Docket No. 11-AFC-01

## Rob Simpson's and Helping Hand Tools Supplement Comments to the PMPD Part 2 of 5

Re: Preliminary Determination of Compliance for proposed development of the Pio Pico Energy Center (District Application No. APCD2010-APP-001251),

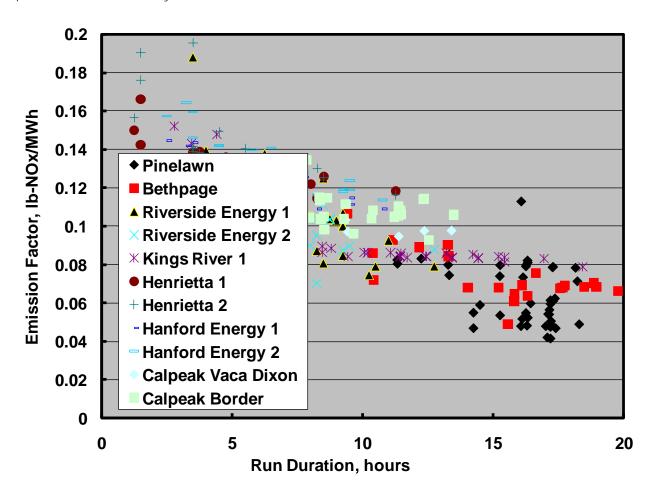
The figure below shows median NOx emission factors for a sample of both combined cycle and simple cycle peaking power plants. Data shown are taken from hourly reported performance and emissions data reported to the U.S. EPA for the months of July and August 2007, and downloaded from the EPA Clean Air Markets database. The darker shaded bars on the left of the graph are for the Pinelawn (first column) and Bethpage (second column) combined cycle peaking power plants located in the State of New York. These are both GE LM6000PC Sprint turbines equipped with OTSG and steam turbines. The remaining data are from peaking power plants across the State of California.

The main bars in this graph represent median NOx emission factors for each start/stop sequence reported over the two month period. Arithmetic mean data did not provide a satisfactory comparison,

The California plants closest in emissions performance to the two combined cycle peaker plants are the Kings River units 1 and 2 indicated in columns 11 and 12 from the left. However, the best emissions factor from Kings River is only comparable to the median value from Bethpage. Some of this might be attributed to the longer average run times at Bethpage and Pinelawn, which allows the start up and shut down emissions to be averaged out over a longer period of time.

This is not borne out across the board, however, when we consider Calpine Gilroy units 3 and 4, shown in columns 17 and 18 from the left. These units frequently operated for durations in excess of 12 hours during the two month period under consideration; and yet in comparing emissions factors with those of Pinelawn and Bethpage for similar operating periods, the Calpine Gilroy units had emission factors more than twice as high. The next figure illustrates the distinction between combined cycle and simple cycle performance more clearly.

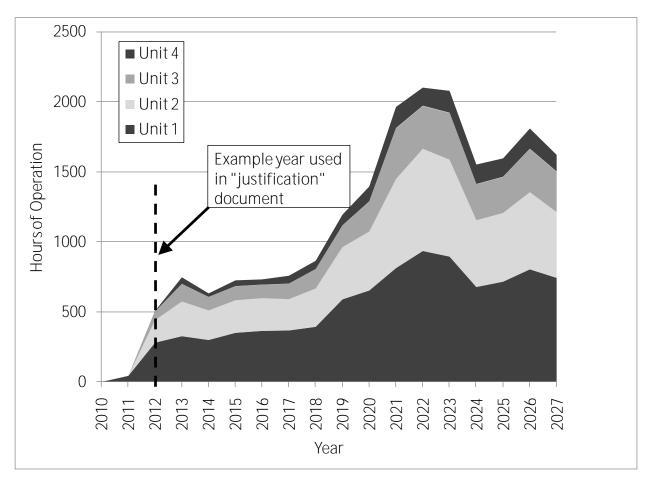
In the figures labeled as Tables 1A through 1C in the "justification" document, there are no examples of the turbines starting up in a ten-minute time frame. In fact, in the document "URS Project Emissions Information" on page 4 it is stated:

This operation is fully compatible with the capabilities of current combined cycle power plant operation where, with OTSG, these turbines can start up and meet these capabilities for power generation without sacrificing reliability or availability.
